<u>SP-24-09</u>	<b>Staff Report – July 29, 2024</b>
<b>Application Type:</b>	Special Use Permit
<b>Project Address:</b>	1601 Lemoyne Avenue (Tax Map ID: 004.-05-03.0), 1611 Lemoyne Avenue To City Line, (Tax Map ID: 004.-05-02.0), 1585 Lemoyne Avenue (Tax Map ID: 004.-05-04.1)
<b>Summary of Proposed Action:</b>	<p>The applicant (Cuse Car Care, LLC.) proposes to change the land use from a heavy automobile repair use type to a light automobile repair use type and build a 2,920 SF (footprint) addition onto the existing building. The existing heavy automobile repair use type is a legal non-conforming land use in the Mixed-Use Transition, MX-3 Zone District. The light automobile repair use type is a conforming use and only permitted by a Special Use Permit in the MX-3 Zone District.</p> <p>The applicant also intends to combine three existing lots (1601 Lemoyne Ave., 1611 Lemoyne Ave., and 1585 Lemoyne Ave.) to become one new lot (new 1601 Lemoyne Ave.) for the proposed light automobile repair use and proposed building expansion.</p> <p>The total gross floor area of the proposed building is 5,840 SF (2-story) and the existing building is 3,165 SF (1 story). The total gross floor area of t

CUSE CARS, LLC  
SUBDIVISION  
PRELIMINARY PLAN

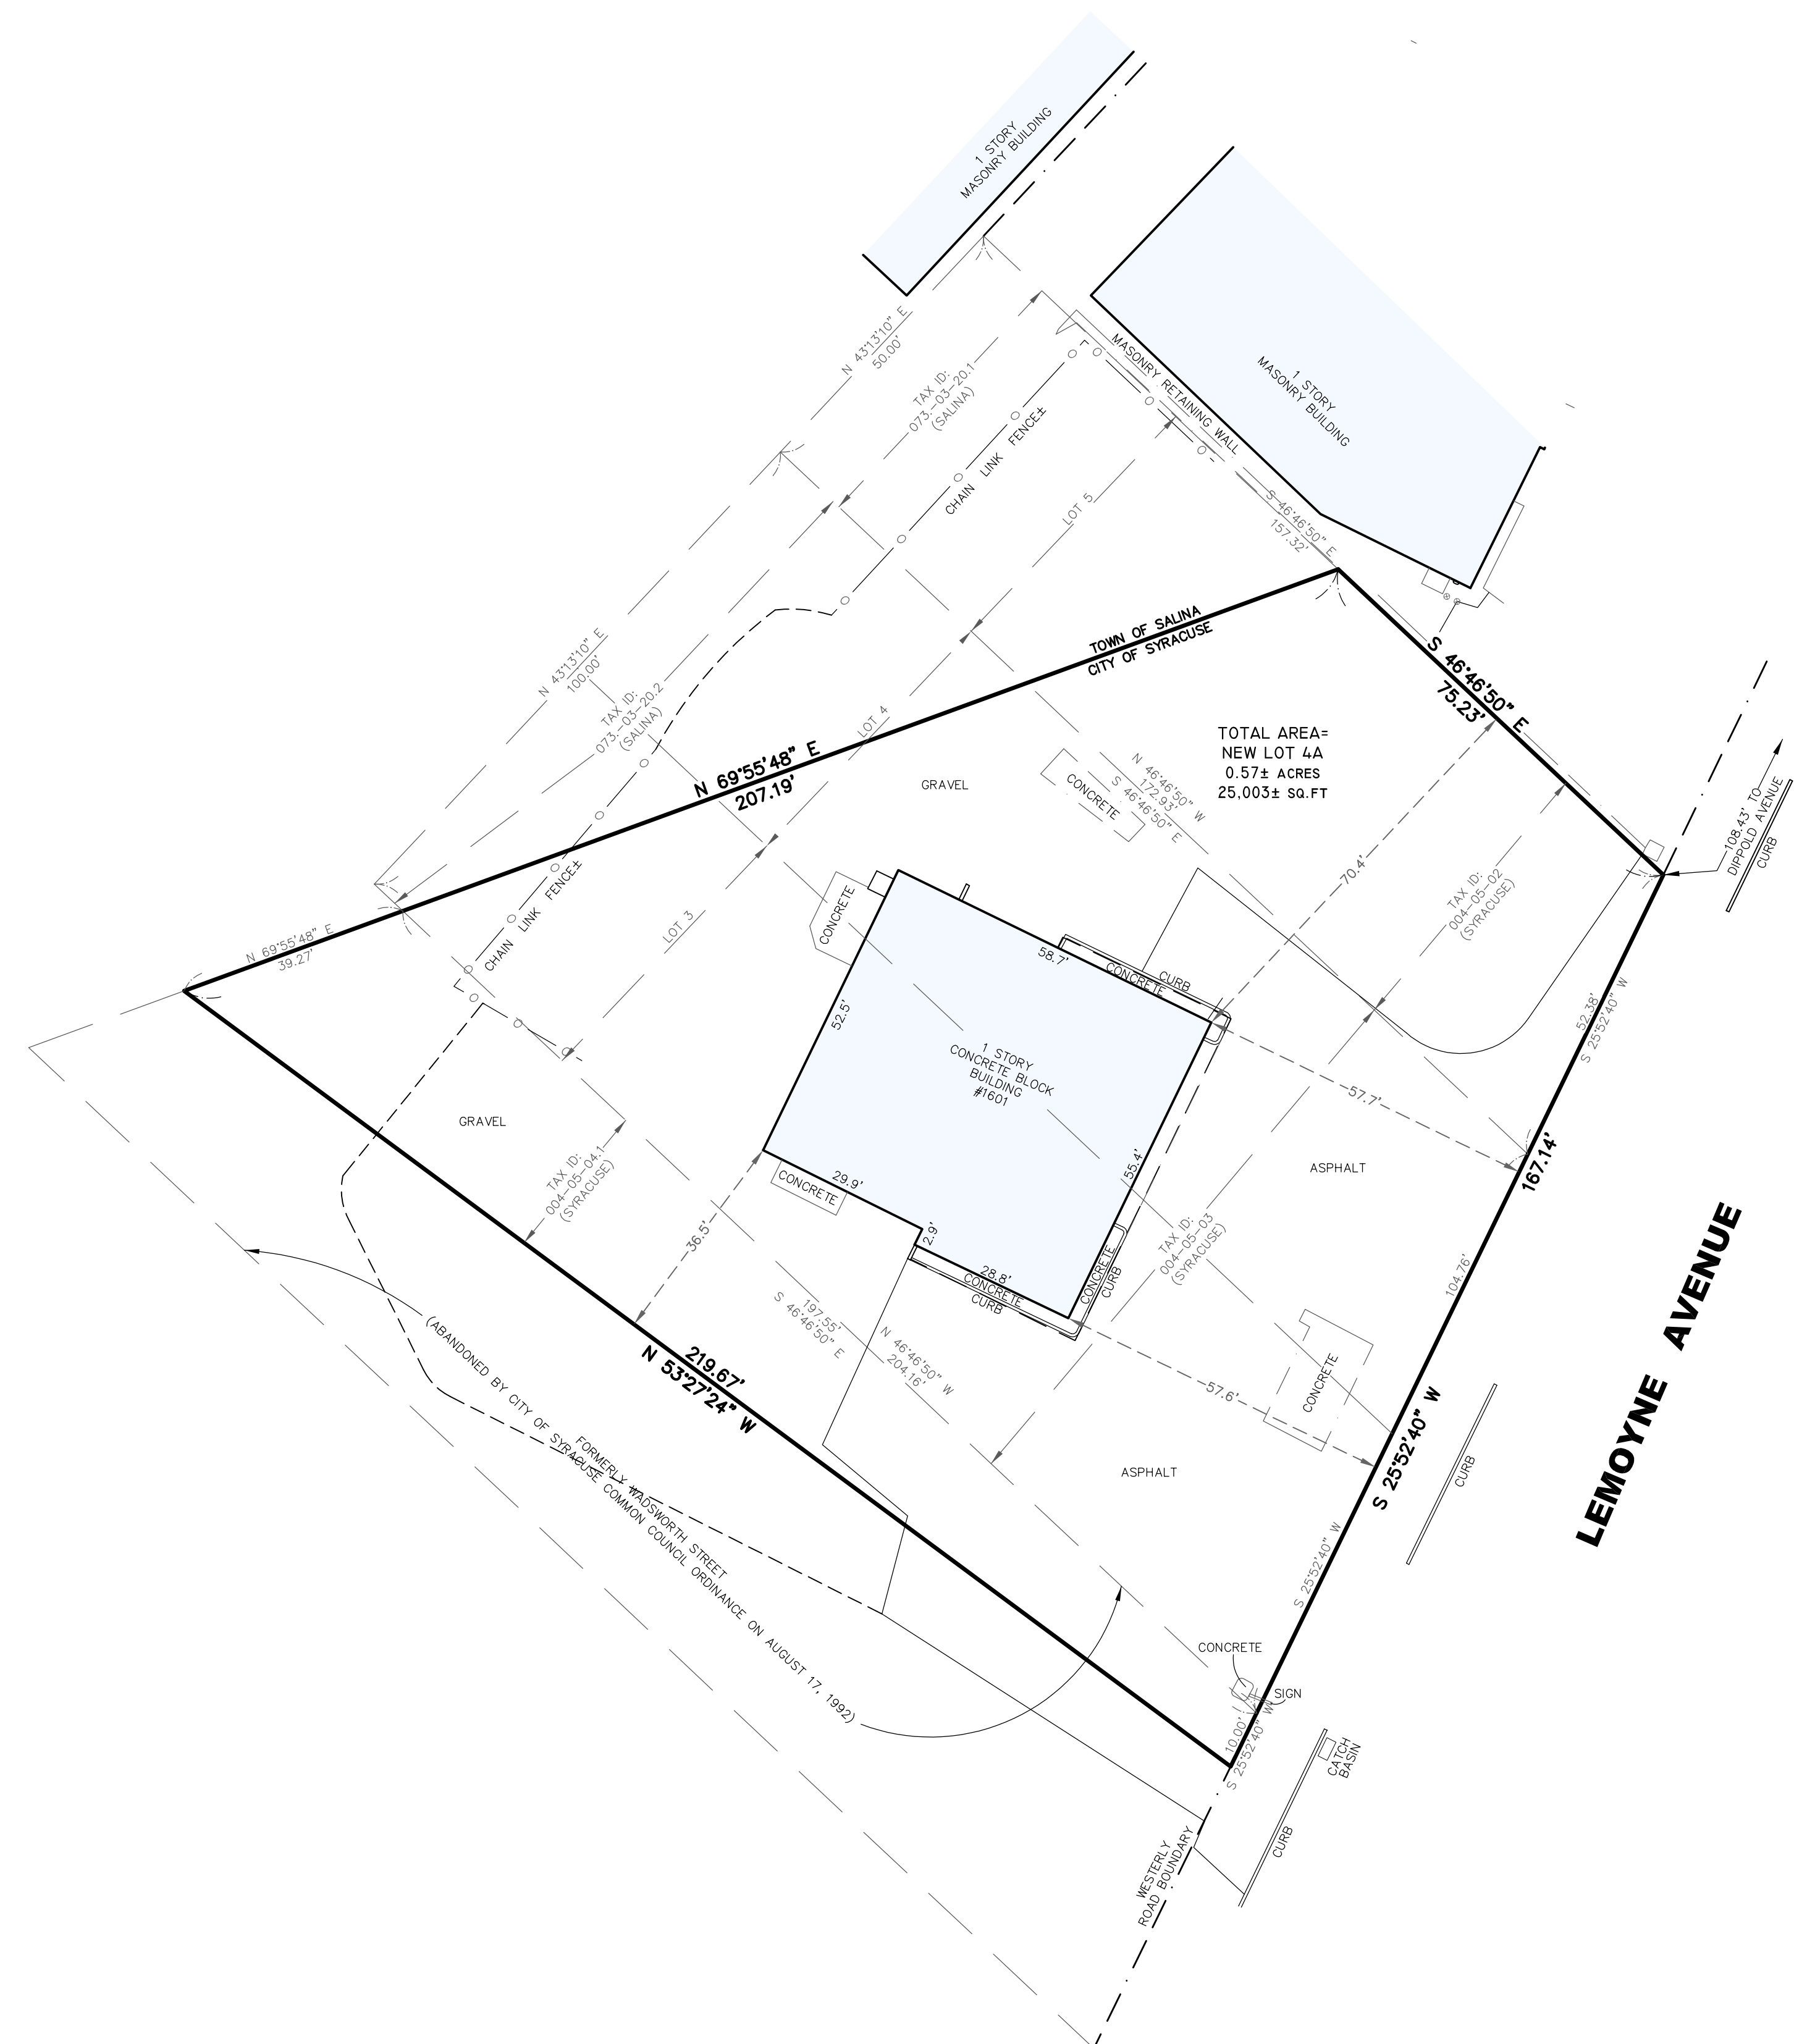
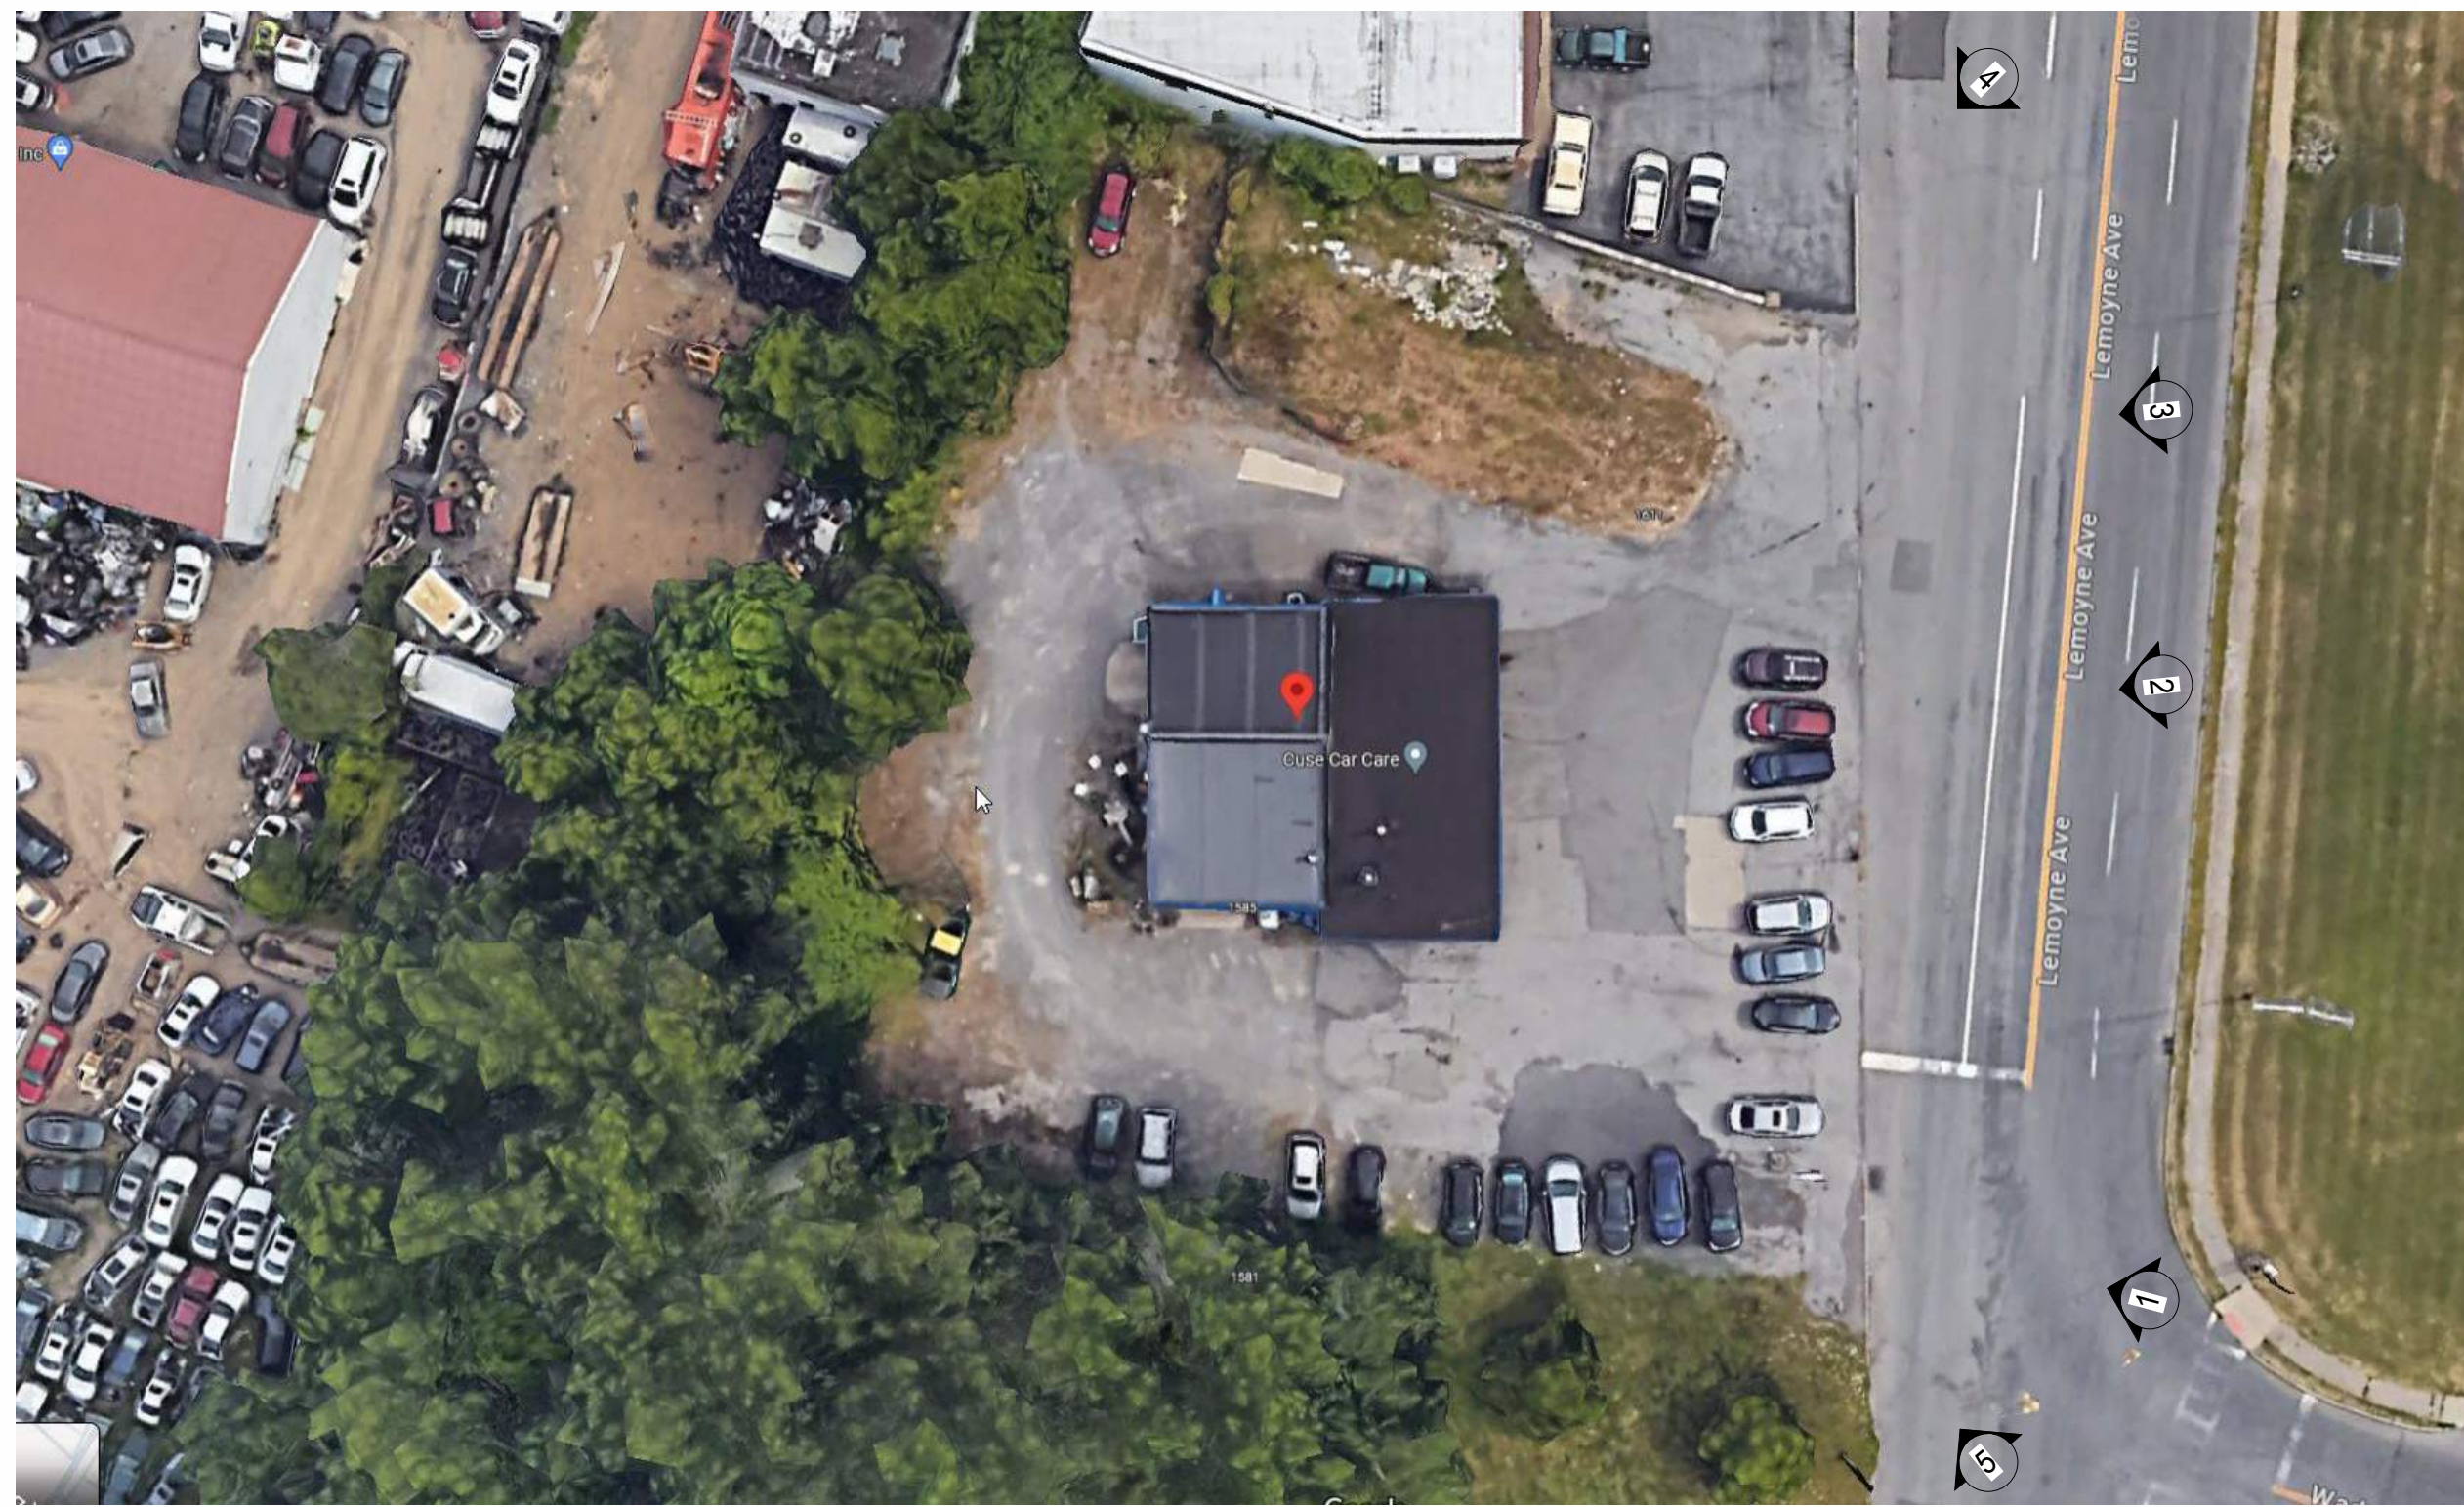
- WHEREAS, per the Cuse Cars, LLC Subdivision Plan dated 3/22/23, the applicant is proposing to combine the three City of Syracuse parcels into one new 0.57-acre lot; no changes were proposed to the two Town of Salina parcels, but the Site Plans depict some of the proposed work to occur within the Town; and

Approval	Status	Status Date	Reviewer	Comments
Zoning Planner	Pending	04/17/2024		The proposed lot complies with the Rezone lot design standard in MX-3
Eng. Mapping - Zoning	Approved	04/23/2024	Ray Wills	-The bearings for the streets in question cannot be confirmed or denied via Official City ROW records. As they lie in an area outside of the plats available.
Finance - Zoning	Internal Review Complete	04/18/2024	Veronica Voss	1585, 1601 and 1611 Lemoyne tax bills are all paid in full; no taxes due.
Eng Stormwater (SWPPP)-Zoning	Internal Review Complete	04/26/2024	Mirza Malkoc	<ul style="list-style-type: none"> <li>Proposed site elevations shall be graded to prevent stormwater sheet flow to adjoining properties &amp; to the City R.O.W.</li> <li>This is just a reminder that a Stormwater Pollution Prevention Plan (SWPPP) is required for review if the total soil disturbance is greater than 10,000sf.</li> </ul>
